REMARKS

This is a full and timely response to the outstanding final Office Action (Paper No. 15) mailed February 6, 2004. Claims 5, 6, 9, 12, 13, 15 - 19, and 22 have been cancelled in previous amendments without prejudice, waiver, or disclaimer. Claims 4 and 11 are canceled in this amendment without prejudice, waiver, or disclaimer. Claims 1 and 7 have been amended. The subject matter of amended claims 1 and 7 is contained within FIGs. 5 – 13 and the related detailed description of the specification. Consequently, no new matter has been added to the application.

APPENDIX A

ANNOTATED DRAWING SHEET

FIG. 5

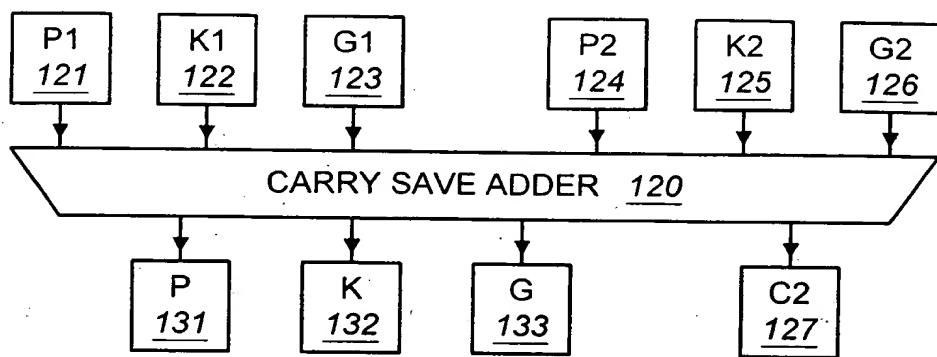
FIG. 5 has been amended to correct column labels. The corrected labels in the table of FIG. 5 correspond to respective values generated by the carry-save adder illustrated in FIG. 4. Accordingly, no new matter has been introduced to the application.
